ADDENDUM

ADDENDUM NO.: 02

PROJECT NAME: Emiliano Zapata Academy Annex

DATE OF ISSUE: August 23, 2017

DRAWN BY: JW
CHECKED BY: TS
SCALE: 1/16" = 1'-0"
FILE NAME: DW_AL_TS_G21_L01 EXIT PLAN W EXIT PLUMB OCC CALC_20170612

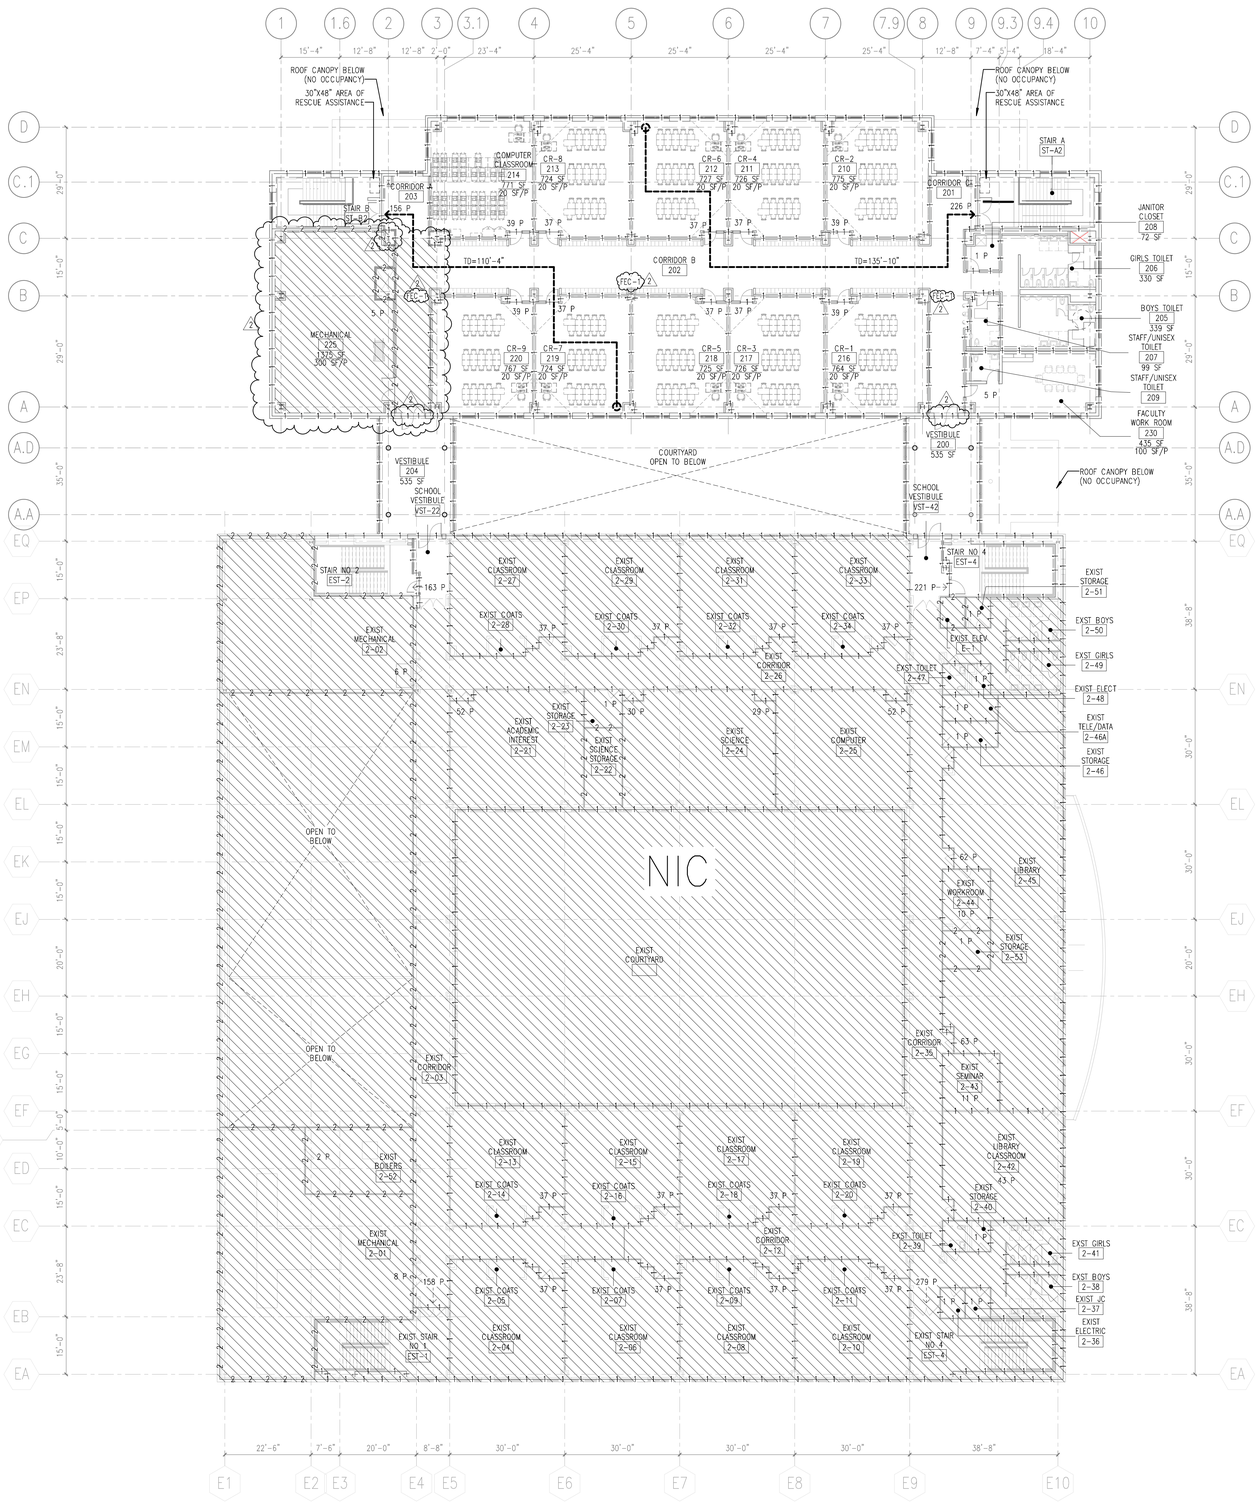
Change 1 SHEET G2.1 Level 01 Exiting Plan with Exiting, Plumbing, and Occupancy Calculations and G2.2 Level 02 Exiting Plan with Exiting, Plumbing, and Occupancy Calculations- ADDED fire extinguisher cabinet symbol to Exiting Plan Legend.

Change 2 SHEET G2.1 Level 01 Exiting Plan with Exiting, Plumbing, and Occupancy Calculations and G2.2 Level 02 Exiting Plan with Exiting, Plumbing, and Occupancy Calculations – ADDED fire extinguisher cabinets at Column enclosures B3, B5, and B9 in both levels' Corridors, and in the Servery.

Change 3 SHEET G2.1 Level 01 Exiting Plan with Exiting, Plumbing, and Occupancy Calculations and G2.2 Level 02 Exiting Plan with Exiting, Plumbing, and Occupancy Calculations – ADDED note and hatch for spray-applied cementitious fireproofing to Exiting Plan Legend.

DRAWING NO.
G2.2

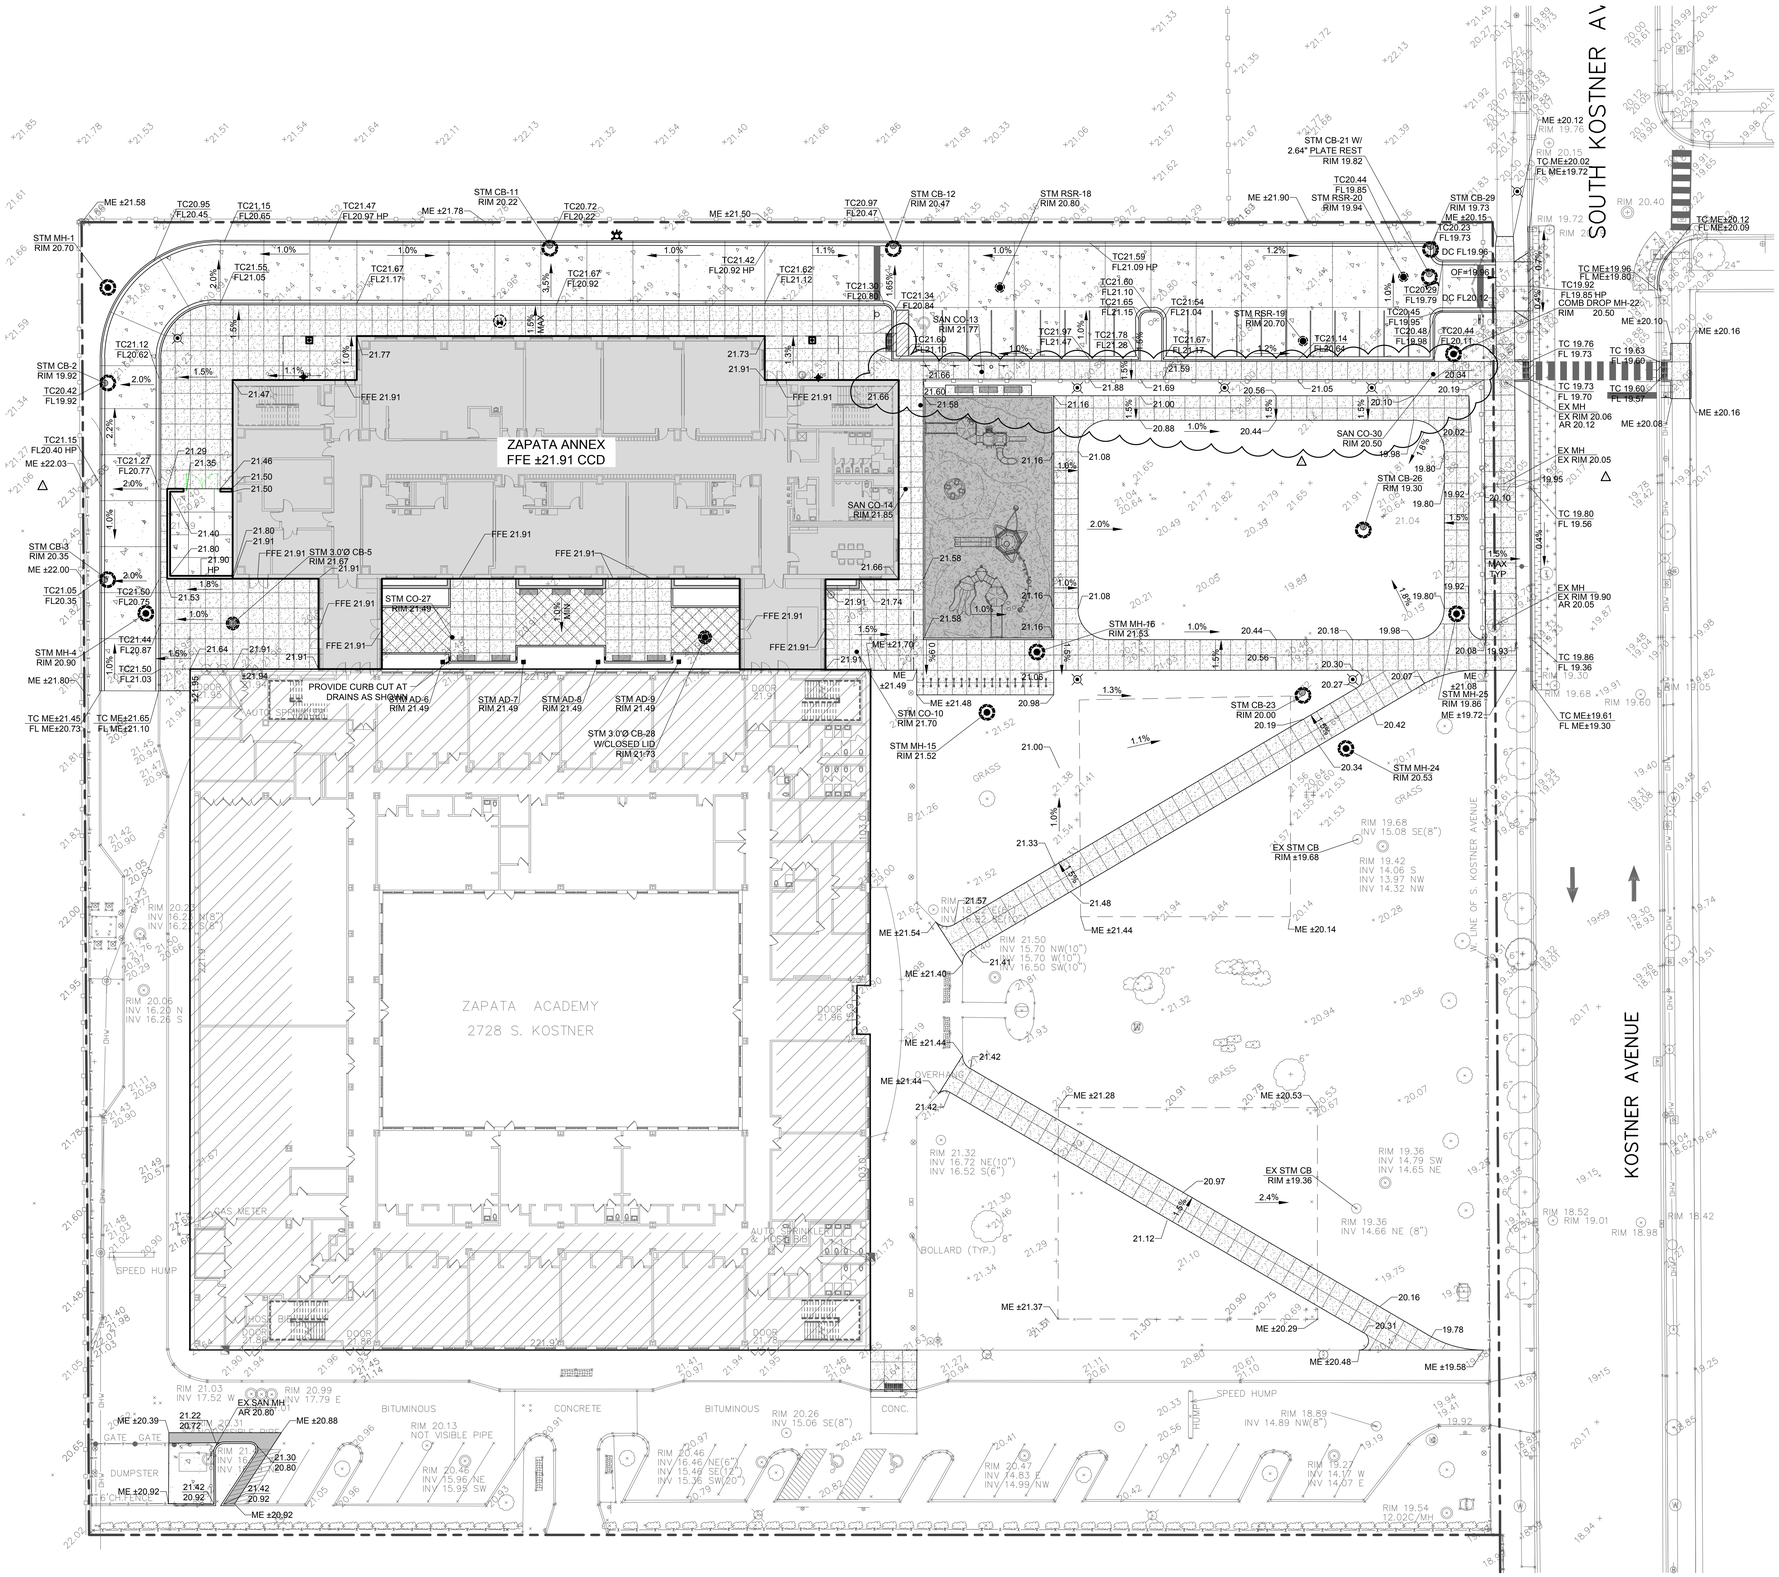
Change 4 SHEET G2.2 Level 02 Exiting Plan with Exiting, Plumbing, and Occupancy Calculations – ADDED note and hatch for spray-applied cementitious fireproofing to the Exiting Plan Legend.

Change 5 SHEET G2.2 Level 02 Exiting Plan with Exiting, Plumbing, and Occupancy Calculations – REVISED fire ratings of Column C2 enclosure.

Change 6 SHEET G2.2 Level 02 Exiting Plan with Exiting, Plumbing, and Occupancy Calculations – REVISED fire rating of exterior wall assembly between Columns A2 and A3, and Columns A8 and A9 to match Level 01.

DRAWING NO.
L1.0

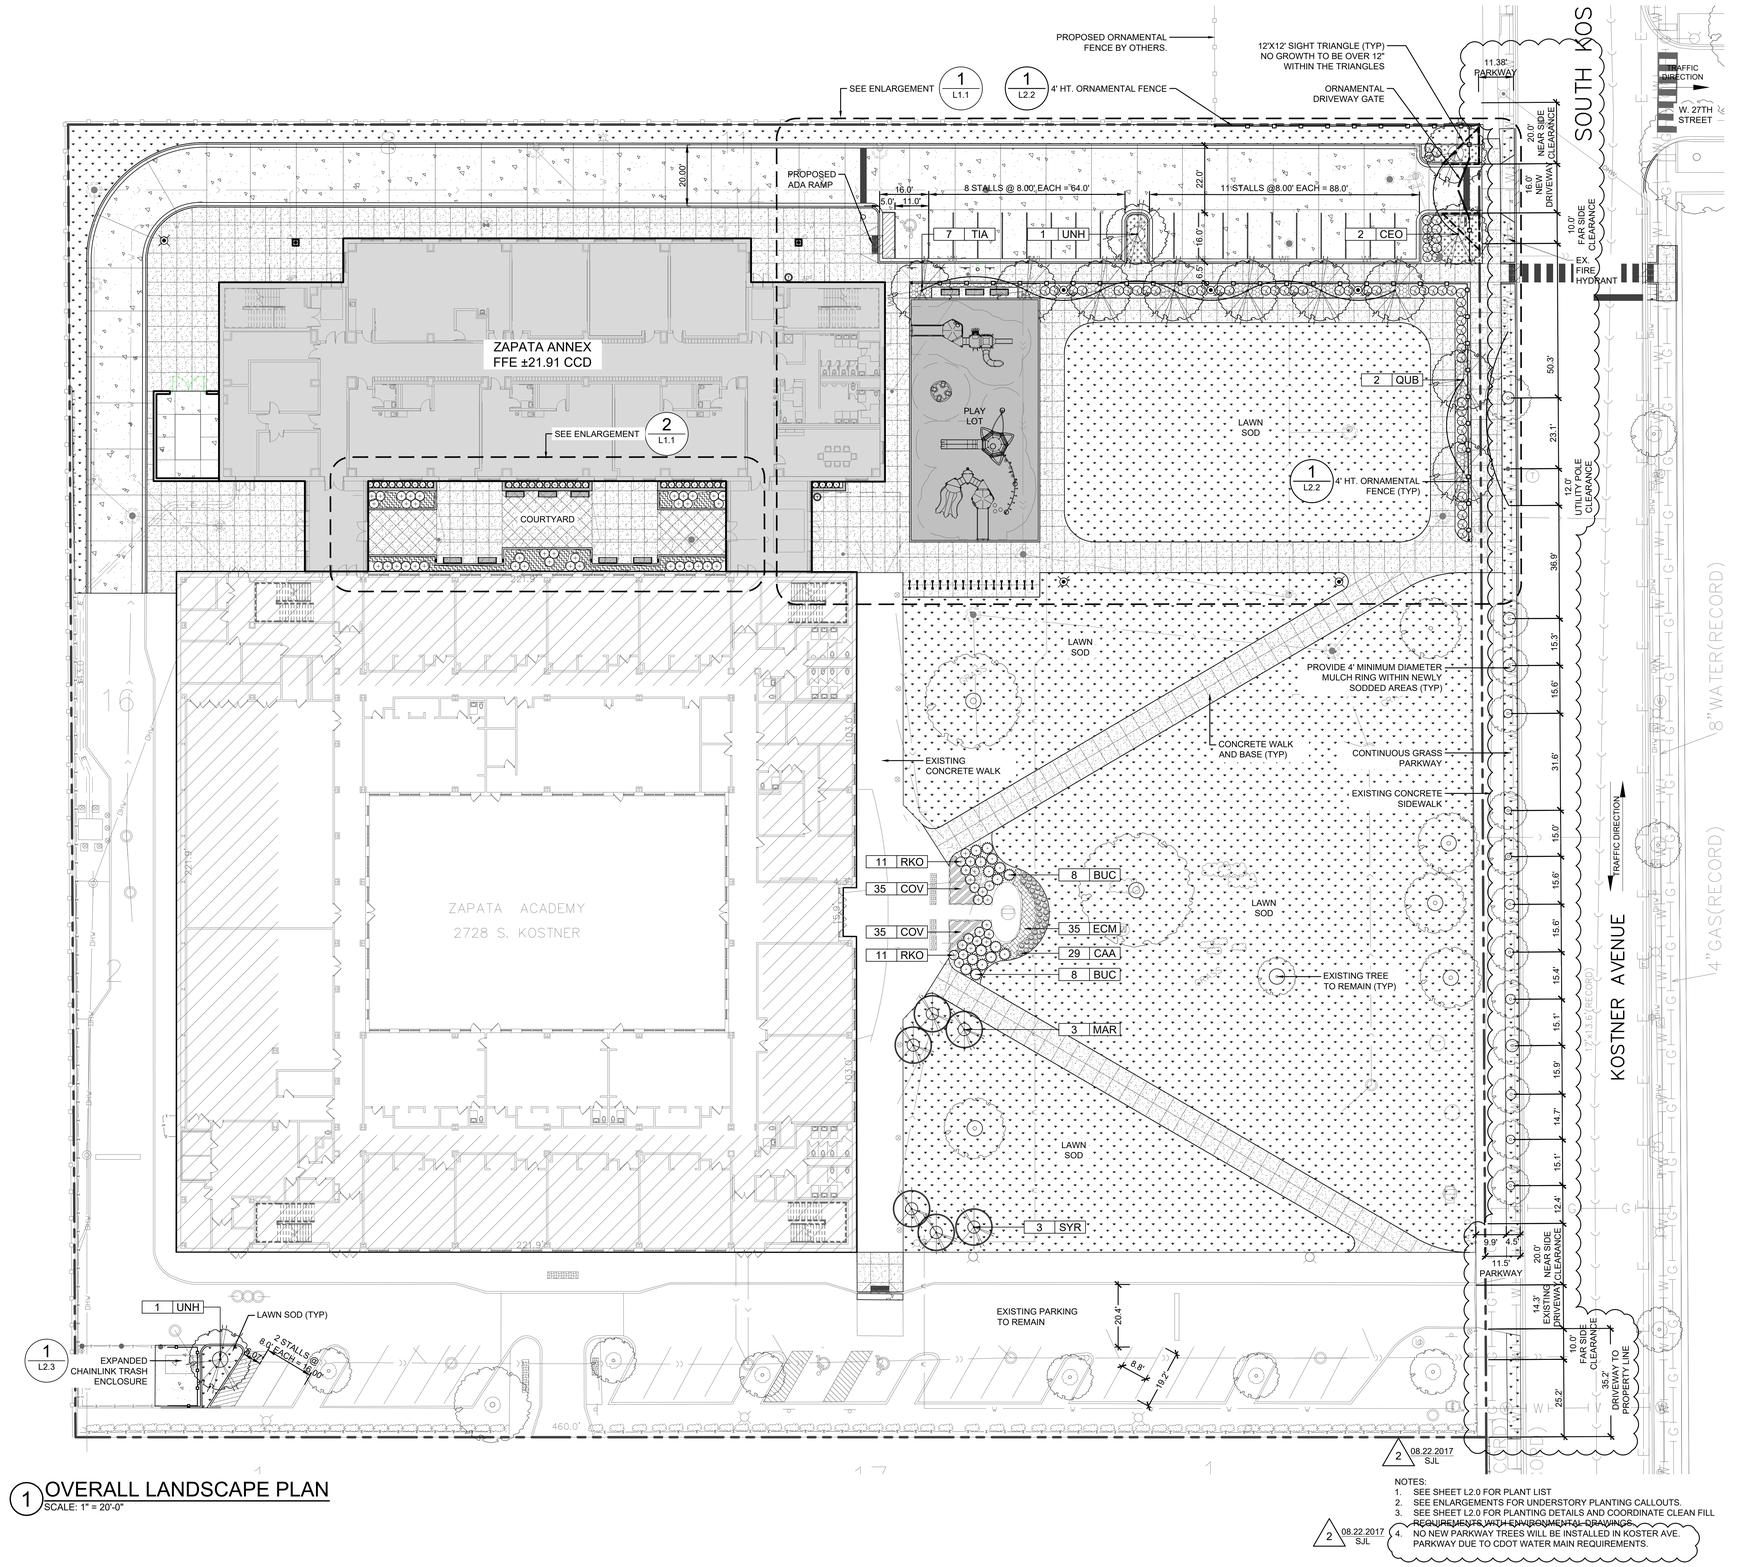
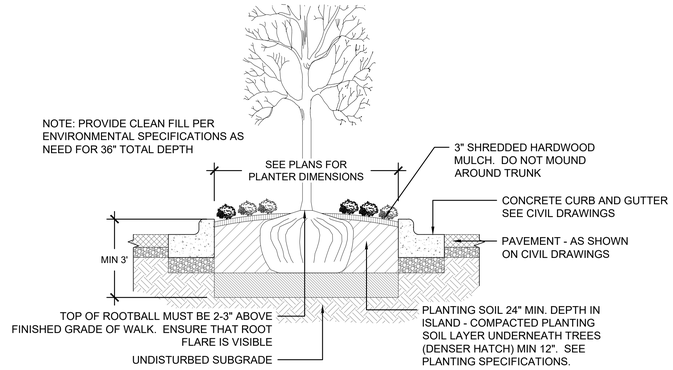
Change 11 SHEET L1.0 Overall Landscape Plan – DELETED Parkway trees along Kostner Ave, (2) GYD & (1) CEO.

Change 12 SHEET L1.0 Overall Landscape Plan – ADDED note for parkway trees to general notes.

1 CONTINUOUS TREE PARKWAY
SCALE: NTS

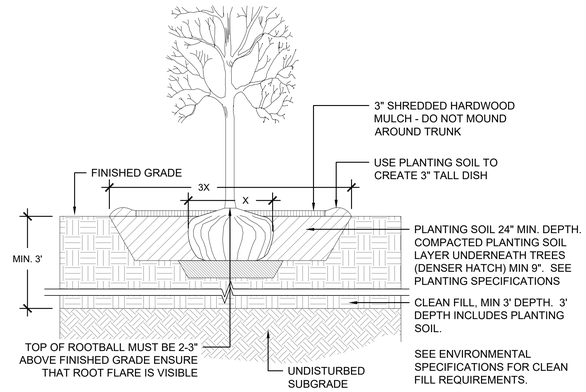
Change 13 SHEET L2.0 Landscape Details – DELETED Detail 1 – Continuous tree parkway.

DRAWING NO.
A2.1

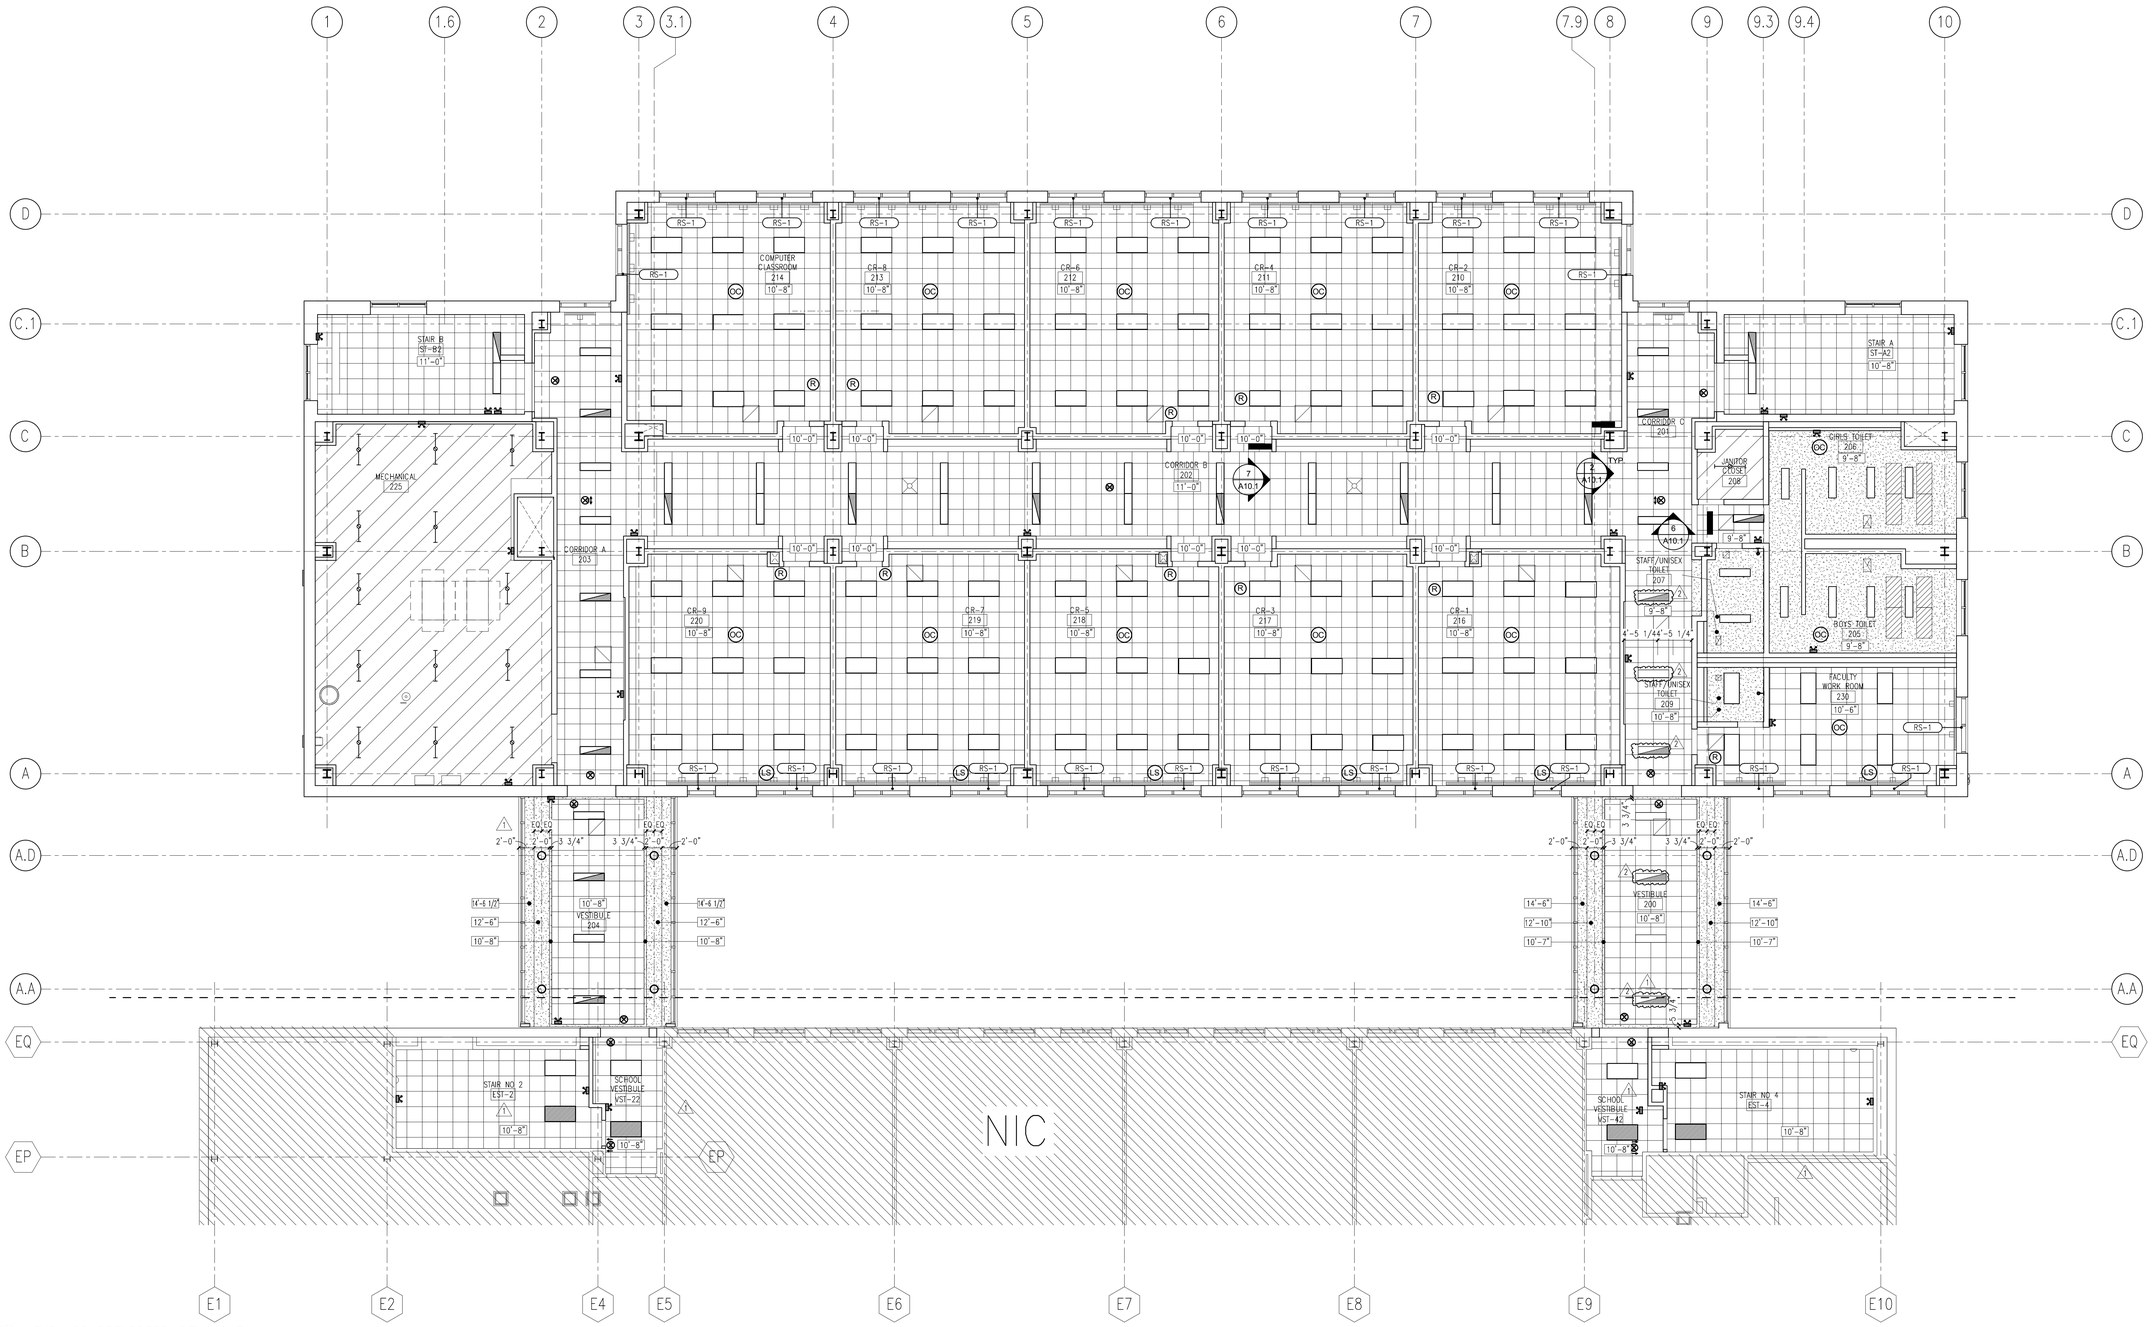
Change 25 SHEET A2.1 Level 01 Reflected Ceiling Plan – ADDED HLB-1 to Admin 130.

Change 26 SHEET A2.1 Level 01 Reflected Ceiling Plan – DELETED exit signs.

Change 27 SHEET A2.1 Level 01 Reflected Ceiling Plan – ADDED daylight sensors Reference E2.1.

Change 28 SHEET A2.1 Level 01 Reflected Ceiling Plan - REMOVED emergency light fixture.

Change 29 SHEET A2.1 Level 01 Reflected Ceiling Plan - ADDED wall mounted light fixture. Reference E2.1.
